AMENDMENTS TO THE DRAWINGS

REMARKS

FIG. 63

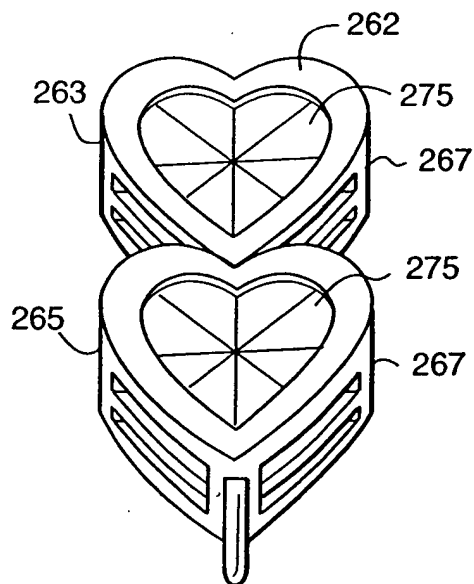
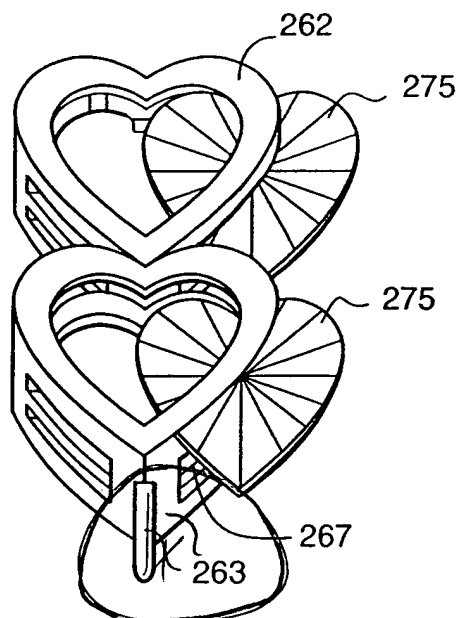
Fig. 63 has been amended so that reference 263 designates clearly the sidewall of the bottom segment of the figure.

In the Action, the drawings are objected to as failing to comply with 37 CFR 1.84 (p)(4). In particular, the Examiner states that "reference character "263" has been used to designate both sidewall, segment, and what appear to be an opening (Figs 60-61)". Page 33 of the specification and figures 60-61 have been amended so that reference 263 now only refers to the sidewall. The Applicants therefore respectfully request the Examiner to withdraw her objection.
